Well Name: LOTOS 10 FEDERAL	Well Location: T24S / R31E / SEC 10 / NENE /	County or Parish/State: EDDY / NM
Well Number: 3	Type of Well: OIL WELL	Allottee or Tribe Name:
Lease Number: NMNM29234	Unit or CA Name:	Unit or CA Number:
US Well Number: 300152979800S1	Well Status: Producing Oil Well	Operator: CHEVRON USA INCORPORATED

Sundry ID: 2722402

Type of Action: Plug and Abandonment

PROPOSED WELLBORE DIAGRAM

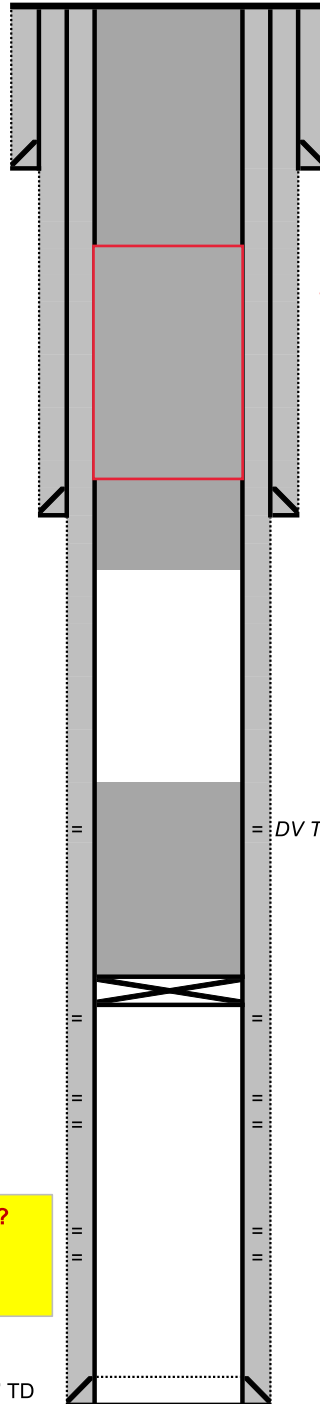
R111P requirements applied. Solid plug from 4484' to surface. Tag and resume as needed if staging

Please spot 25sx plug across
 Cherry Canyon top. 5384' - 5284'
 WOC & Tag 5284' or higher

Created By	Comment	Comment Date
john.harrison	Please see change to P&A procedure on Proposed WBD - Cherry Canyon Plug	4/13/2023
